RE: Section 4.55(2) Modification to Development Consent DA-421/2018 at 5 – 11 Hollywood Avenue, Bondi Junction NSW 2022

This application has been prepared by Mecone on behalf of Iglu No. 208 Pty Ltd pursuant to Section 4.55(2) of the *Environmental Planning and Assessment Act 1979* (EP&A Act) and is submitted to Waverley Council (Council) in relation to the site at 5 – 11 Hollywood Avenue, Bondi Junction (the site).

Figure 2 Approved Basement Design (left) and Revised Basement Design (right)
 Source: Bates Smart

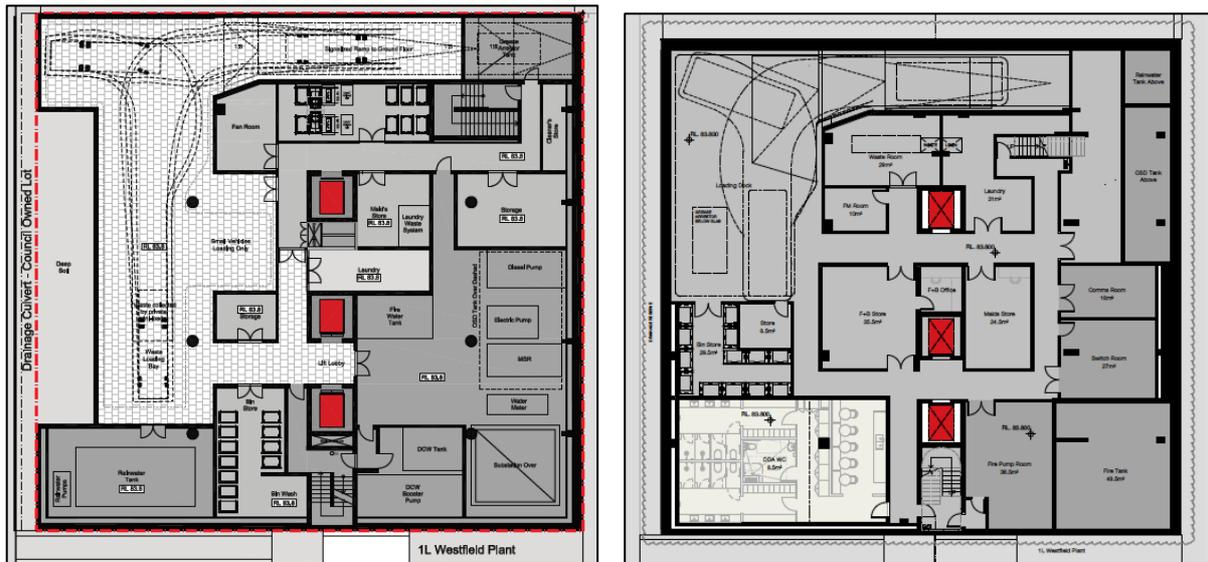
As outlined above, this modification application seeks consent for amendments to the configuration of the basement layout (refer to **Figure 2**). The amendments are a consequence of on-going design development and are minor in nature on the basis that the basement's general arrangement remains unchanged. Specifically, the location of the driveway / loading dock and plant remains consistent with the approval.

The most notable changes relate to the inclusion of W/C amenities in lieu of the rainwater tank along the south western boundary; relocation of the rainwater tank to Level 1; and the deletion of the deep soil planting along the western boundary. A waste storage area is proposed adjacent to the W/C facilities.

The amendments necessitate the reconfiguration of the loading dock. Further discussion regarding the functionality of the revised loading dock is included in **Section 8.0**.

Figure 4 Proposed Southern Stair as Viewed from the Southern Elevation Looking North
 Source: Bates Smart

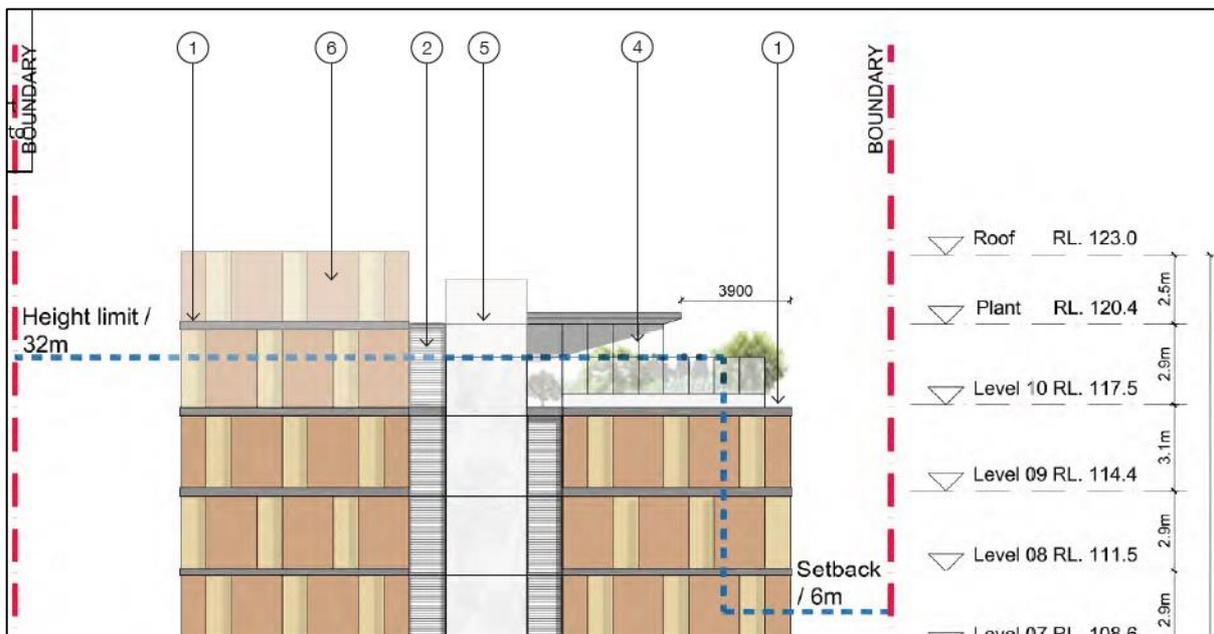
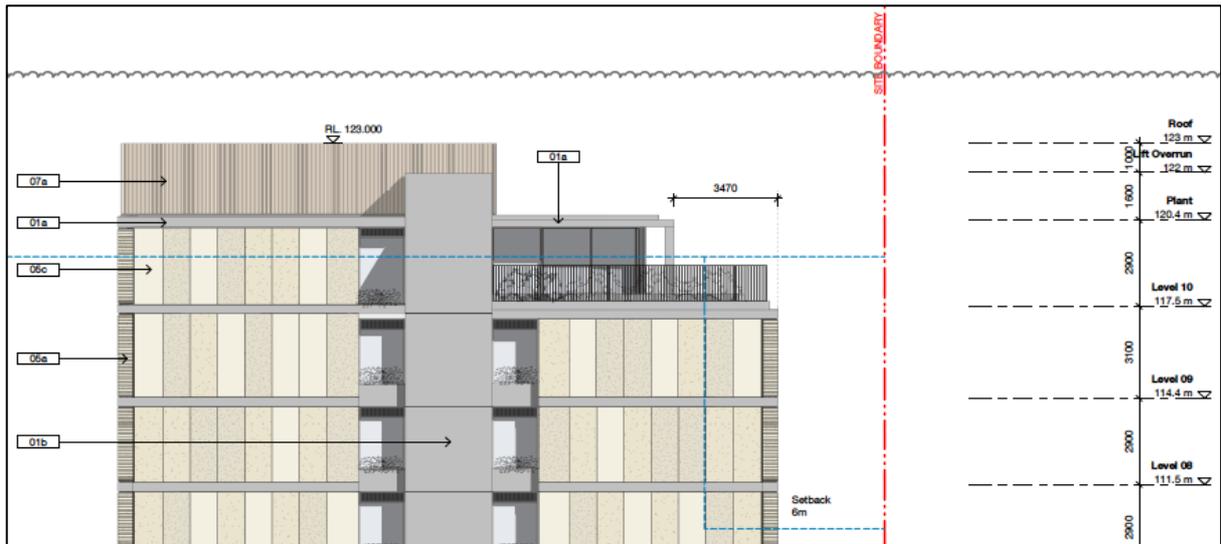
Minor amendments are proposed to the configuration of the roof structures. Specifically, the width of the roof plant screening is proposed to increase in length. Additionally, the height of the roof of the southern stair is proposed to be extended to accommodate the stair pressurisation plenum (refer to **Figure 3 – 4**).

Notwithstanding the proposed amendments, the height of the overall building continues to sit within the approved envelope and does not exceed the approved maximum height of RL 23.00.

Figure 6 Approved Landscaping at the Ground Plane (Left) and Proposed (Right)
Source: Bates Smart

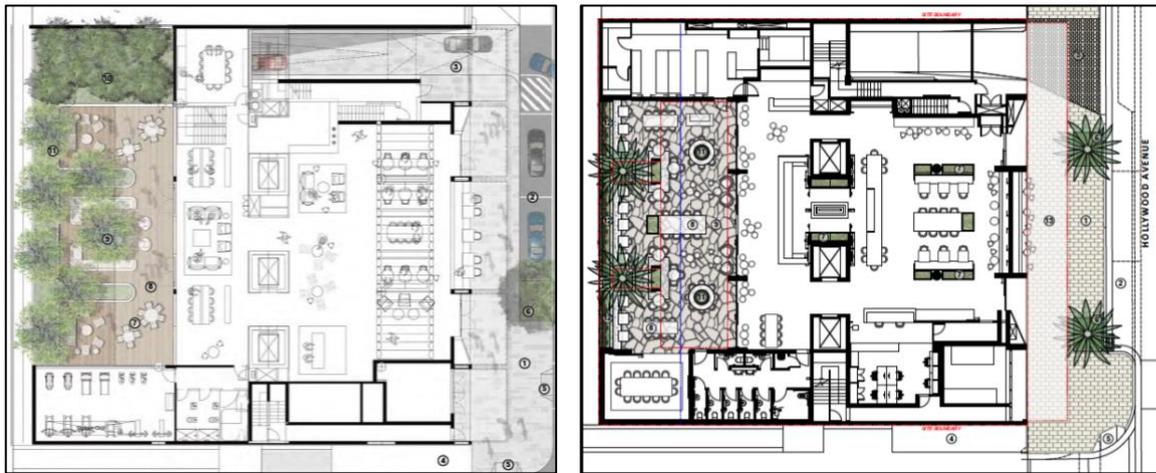
Amendments are proposed at the ground plane within the rear courtyard and adjacent to Hollywood Avenue (refer to **Figure 6**). The approved landscaping within the courtyard consists of timber decking with raised planters along the perimeter containing myrtle trees. The timber decking is proposed to be replaced with paving and the landscaping within the raised planters amended to consist of *Livistona Australis Palms*. *Livistona Australis Palms* are also proposed along Hollywood Avenue in the location of the footpath upgrade that will be undertaken in accordance with Waverley Council's public domain guidelines. Whilst the area of deep soil at the rear has been removed, there are no provisions within the WDCP 2012 that necessitate the provision of areas of deep soil for hotels.

Figure 7 Approved Landscape Design (Left) and Proposed (Right)
Source: Bates Smart

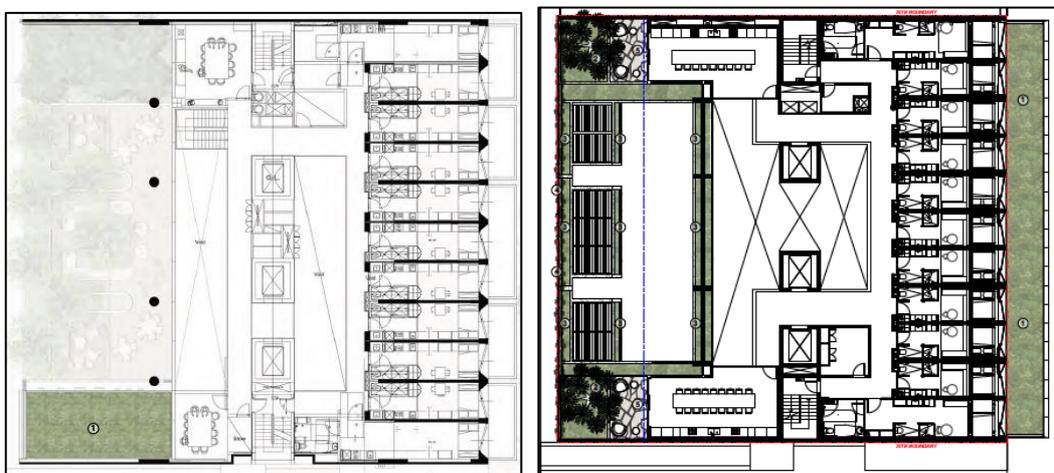
The landscaping at Level 1 is proposed to be amended to increase the amount of greenery visible from the streetscape (refer to **Figure 7**). Landscaping comprising a garden bed is proposed above the awning and will contribute greenery to the streetscape. Towards the rear, elevated planters are proposed above the courtyard and will include cascade planting species and climbing plants that will provide shade and privacy screening.

Figure 8 Approved (Left) Revised Courtyard Design (Right)

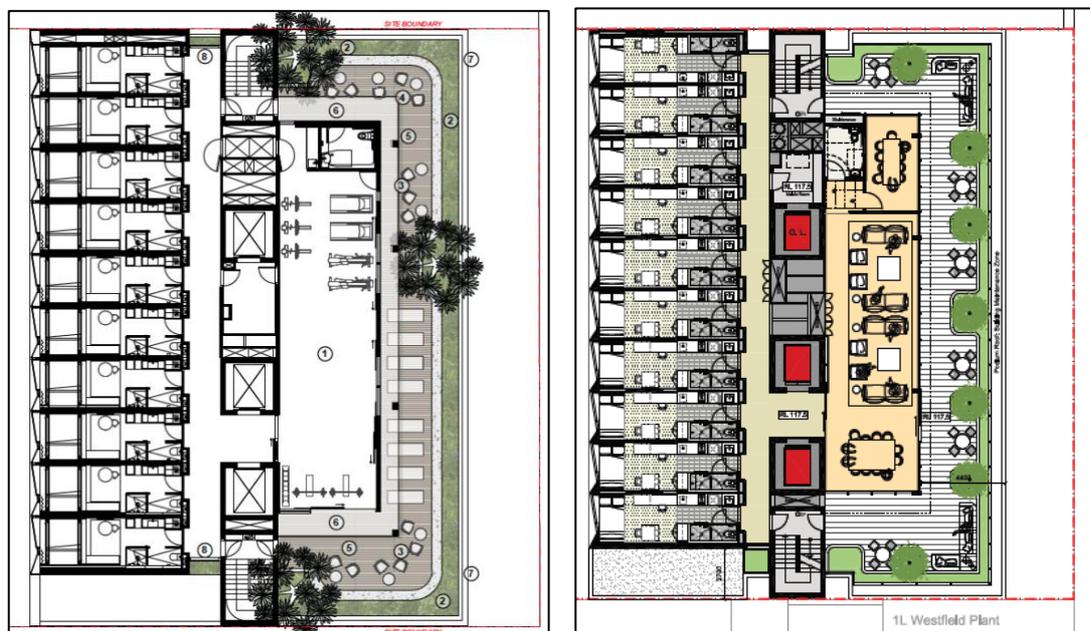
Changes are proposed to the rooftop communal terrace and relate to the rationalisation of the landscaping. As shown in the figure below, the planters around the perimeter are proposed to increase slightly in width and the approved tree planting consisting of *Cupaniopsis Anacardioides* trees is proposed to be replaced with three (3) *Pandanus Tectorius* Trees.
